AR-08-1286

Southern Nuclear Operating Company
Vogtle Early Site Permit Application
Response to Request for Additional Information Letter No. 11
Involving Groundwater

Response to NRC RAI Letter No. 11

Involving Groundwater

Figure 1 - Wetlands on the tributary to Daniels Branch west of proposed Units 3 & 4 and boundary conditions used in the groundwater model.

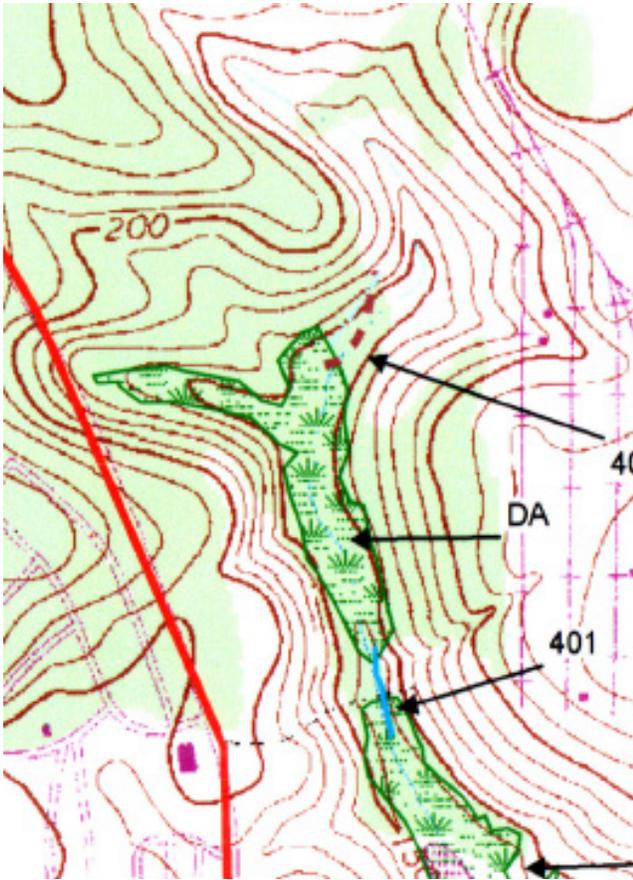
The model should also better simulate flow associated with the tributary to the Daniels Branch. According to the wetland report submitted by Southern (see January 2007 submittal), the tributary to Daniels Branch that lies to the west of the cooling tower area includes segments of an ephemeral stream (adjacent to OW-1007), wetland, and a perennial stream. The perennial stream is upstream of Lower Debris Basin 2. The baseline model could exhibit groundwater flow toward each of these segments of the stream during the wetter period of the year (e.g., March); determine whether it should do so for the perennial stream segment as well. In the real setting based on groundwater observations, groundwater flow occurs from the proposed cooling tower area to the tributary to Daniels Branch; however, in the simulated setting it does not. Furthermore, the potentiometric surface shown for Model 7 (see Figure 50) suggests that groundwater flow occurs across or through the streambed and continues in a northerly direction even though the topographic data suggests the streambed is below the groundwater level in this vicinity. To the extent that the groundwater model does not appear to acknowledge the presence of the streambed, assess whether the perennial stream segment may be better represented by a constant head boundary condition rather than a “drain.”

2. The tributary to Daniels Branch, located west of proposed Units 3 & 4, was represented by a combination of drain and constant head cells (Figure 1). Most of the streambed of this tributary is represented by drain cells. The drain elevation at these cells was set equal to the stream invert elevation based on topographic data. A pond exists upstream of Debris Basin # 2. This pond was most likely created by a beaver dam. A photograph of this pond taken on April 22, 2008 is shown in Figure 2. It is noted that no rainfall had been recorded in the 30 days prior to that date. This pond can also be seen in aerial photographs of this area, suggesting that it is a permanent feature. Therefore, the area of the pond was represented in the model by constant head cells at elevation 150 ft.

Figure 3 - Recharge zones used in the baseline groundwater model

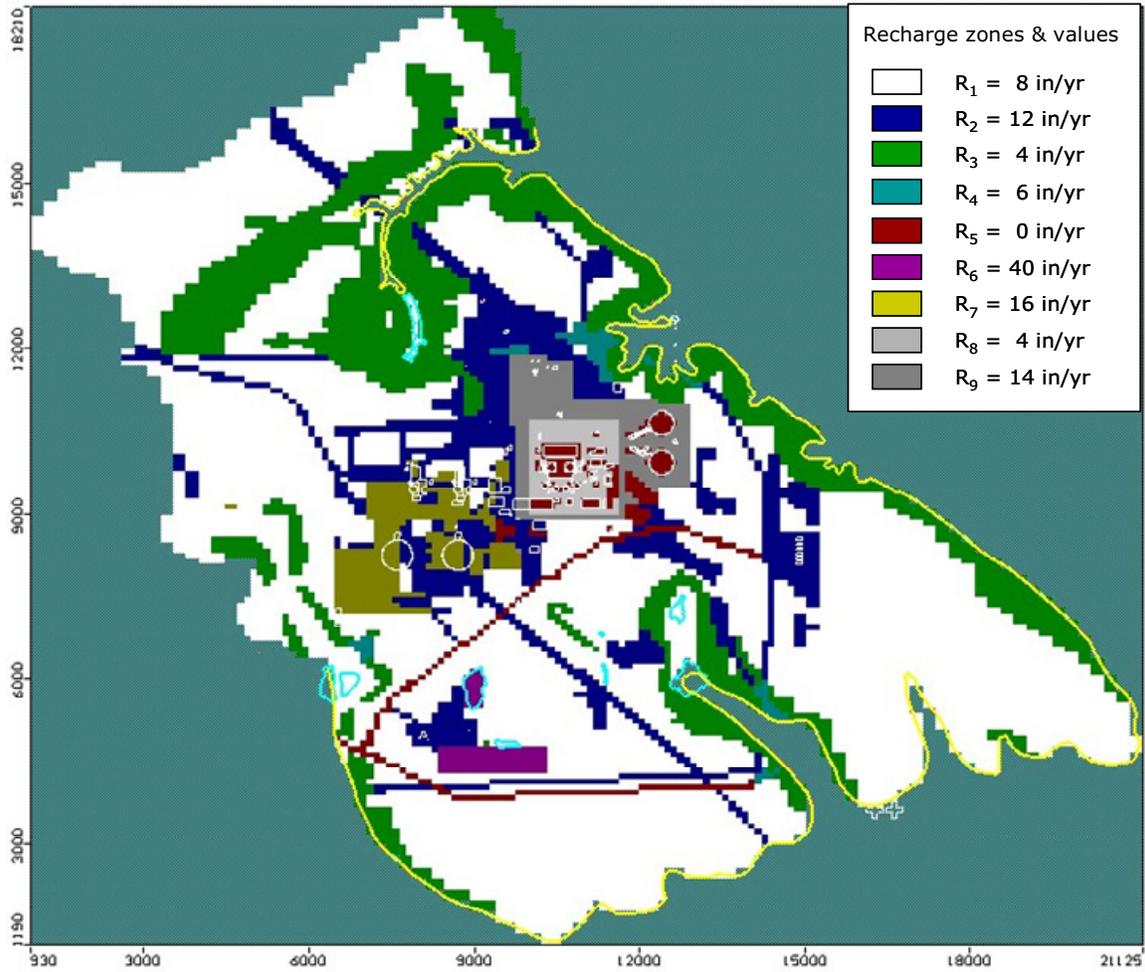
2.4.12-5 Provide a version of the baseline groundwater model (i.e., the model of the existing water table aquifer) that better accounts for the field data concerning both (1) the known groundwater high (which lies below the proposed cooling towers) and (2) the topography and flow around the tributary to Daniels Branch (which is to the west of the cooling tower area proposed for Units 3 and 4). The model should provide a plausible conservative representation of the real system in order to address whether changes in the hydrology necessary to cause a shift in the groundwater flow path are plausible.

3. Three new recharge zones were introduced in the model (see Figure 3):
 - Nearly horizontal areas covered with gravel, which are expected to have relatively higher recharge than horizontal areas, and areas on mild slopes with grass. This zone is mostly around the area of Unit 3 & 4, which served as the construction yard for Units 1 & 2 (zone R₇ in Figure 3).

- Nearly horizontal but well drained areas around the power block of Units 1 & 2, where runoff is collected and recharge is expected to be relatively low (zone R₈ in Figure 3).

- Nearly horizontal graded areas with compacted gravel around Units 1 & 2 (e.g. the switchyard area), where recharge can be high, but less than in areas where the gravel has not been compacted (zone R₉ in Figure 3).

Figure 4 - Hydraulic conductivity zones in the baseline groundwater model.

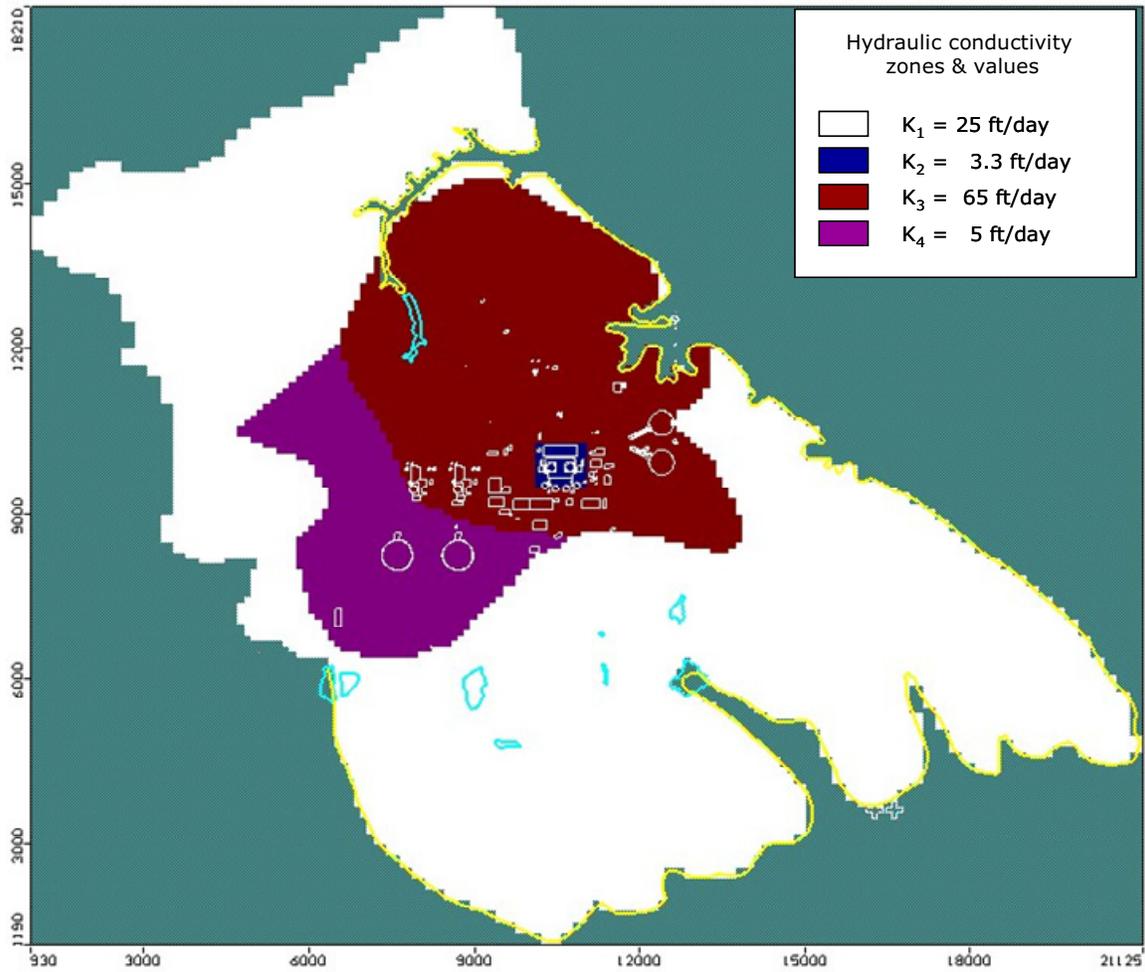
2.4.12-7 Based on the revised baseline model incorporating the further assessment of infiltration rate assignments – i.e., the most plausible conservative conceptual model of today’s site – provide an analysis of (1) the magnitude of change in hydraulic conductivity, if any, that would cause a groundwater flow path to exist to the west or southwest from the power block area, (2) the spatial distribution and magnitude of infiltration rate changes, if any, that would cause a groundwater flow path to exist to the west or southwest of the power block area, and (3) combinations of the above.

4. The hydraulic conductivity distribution was revised to improve the agreement between model and data. Figure 4 shows the delineation of the hydraulic conductivity zones used in the baseline model. These zones include the backfill material used for the construction of Units 1 & 2 (K₂ in Figure 4), a zone that encompasses part of the area where the Utley limestone is present (K₃ in Figure 4), and a low conductivity zone to the west of Units 3 and 4 (K₄ in Figure 4). The rest of the model domain is treated as a uniform hydraulic conductivity zone (K₁ in Figure 4).

An overview of the process and the rationale used for the development of the zones shown in Figure 4 is provided below. Different combinations of the extent and hydraulic conductivity value of zone K₄ were evaluated in the effort to improve the agreement between simulated and measured groundwater levels. As zone K₄ neighbors zone K₃, adjustments in the extent of zone K₄ also affected the extent of zone K₃. In addition to the baseline model, which consists of the four hydraulic conductivity zones described above, the model changes described under items (1) through (3) above, were also introduced in different models 1 through 7 described in Appendix 2.4B. The baseline model presented here is a modified version of Model 7 in Appendix 2.4B. It has the same general hydraulic conductivity zones as Model 7 presented in Appendix 2.4B, but differs in the extent of the low conductivity zone to the west of Units 3 & 4.

After evaluating a large number of combinations of hydraulic conductivity values for the conductivity zones in the baseline model (see Figure 4), it was concluded that it is not possible to produce groundwater

Figure 9 - Recharge zones around Units 1 & 2 and the proposed Units under present conditions.

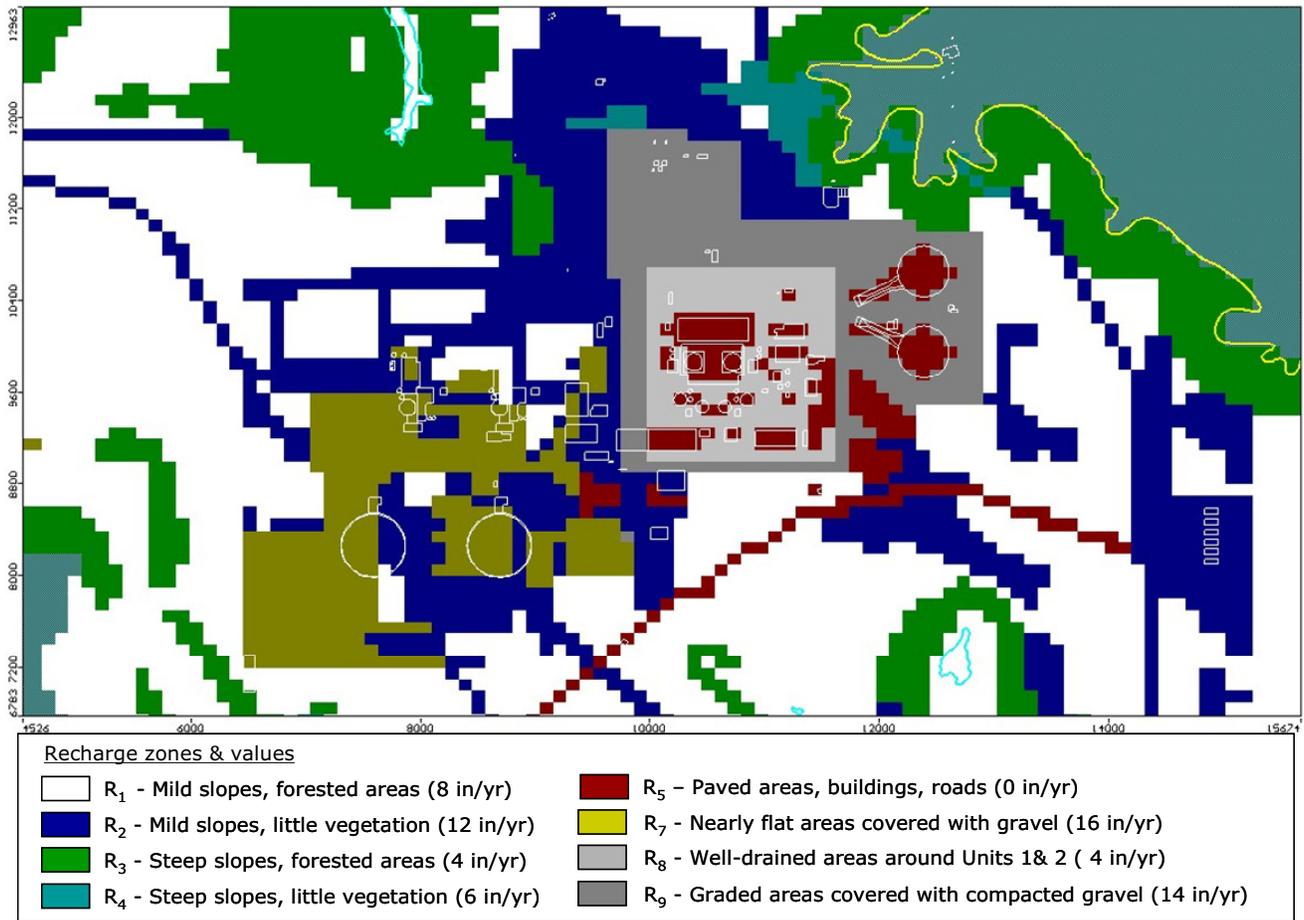
2.4.12-6 Provide a further assessment of the assignment of infiltration rates, with special attention to the potential for higher infiltration in the immediate vicinity of the groundwater high that occurs beneath and adjacent to the proposed cooling towers for Units 3 and 4. The presence of highs or lows in the potentiometric surface of an aquifer suggests sources or sinks of groundwater, respectively. In the case of a broad region of uniform hydraulic conductivity, the presence of a groundwater high suggests a topographic high or a greater amount of infiltration. The region of interest is an area that was reshaped during construction of the existing units, and as a result is relatively flat and may present an opportunity for minimal runoff and maximum recharge. In addition, the presence of asphalt roadways and concrete pads may contribute to runoff to areas prone to infiltration (unlined ditches, water retention basins), with infiltration rates locally approaching if not exceeding precipitation because of the collection area aspect of ditches and basins.

The first new recharge zone (R₇ in Figure 9) covers most of the area that was reshaped during construction of the Units 1 & 2, and as a result is relatively flat, covered mostly with gravel, which may present an opportunity for minimal runoff and maximum recharge. Most of this area was used as the construction yard for Units 1 & 2.

Nearly horizontal graded areas covered with compacted gravel (e.g. the switchyard and other areas around Units 1 & 2) were defined as another recharge zone (R₉ in Figure 9). Recharge over this zone is high but less than zone R₇.

Finally, an area of relatively low recharge was defined to describe the well-drained areas around the power block of Units 1 & 2 (R₈ in Figure 9).

Using these new recharge zones with the values indicated in Figure 9 contributed to the improved calibration of the groundwater model and its ability to simulate the local groundwater high that occurs beneath, and adjacent to, the proposed cooling towers for Units 3 and 4 (see Figure 6).
